**Comments of the California Wind Energy Association
on the CAISO's "Second Revised Draft Final Proposal" on
Flexible Ramping Product and Integrated Day Ahead Market**

Date: October 16, 2012

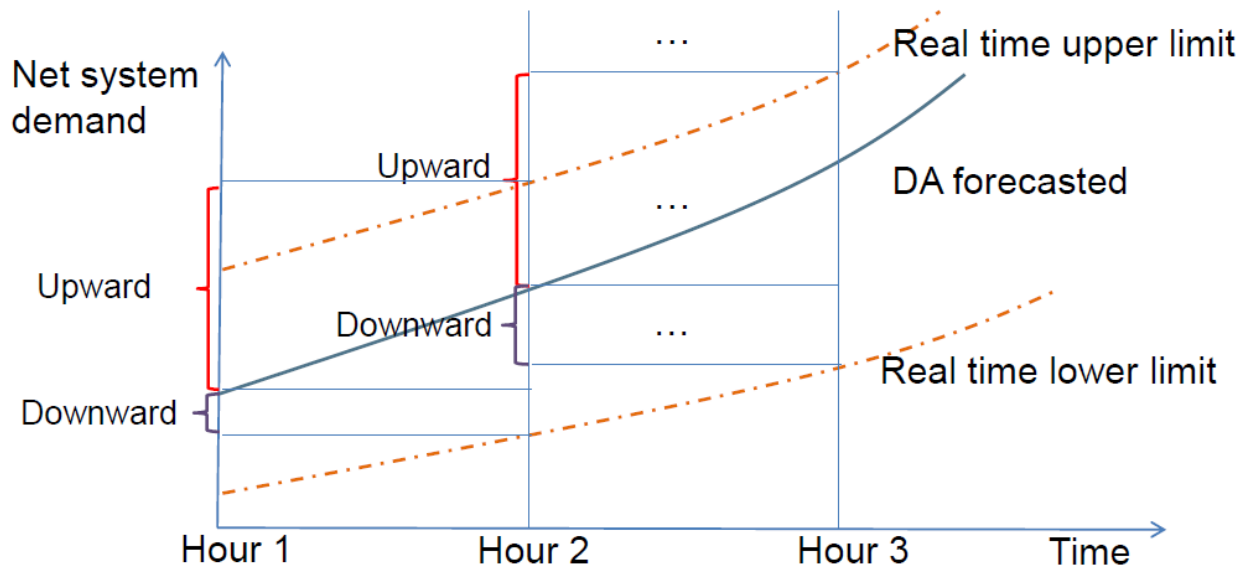
1. **FRP Procurement:** To avoid over-procurement of FRP resources, only the “True FRP” should be procured as part of DA and RT markets. For example, in the DA market (referring to the following figure from the CAISO’s presentation slides on the latest proposal), the True FR-UP (Flexible Ramp Up) capacity at hour 1 would correspond to the difference in the total “real time upper limit” at hour 2 and load forecast at hour 2. We make a distinction between True FRP capacity and the so-called “Real FRP” capacity, because the market has already scheduled, or will schedule, the resources to provide the ramp identified for the load forecast between hours 1 and 2 as part of the energy market anyway. So if CAISO procures the so-called “Real FR-UP,” it will pay twice for the portion of the FR-UP capacity that covers the forecast load, although it will use that capacity only once.

Likewise, in reaction to CAISO’s intention to procure FR-UP and FR-DN (Flexible Down) capacity at every scheduling time interval, CAISO will over-procure if it purchases FRP products in the opposite direction of the dominant net load ramp during the major ramp periods, because that procurement will go unused.
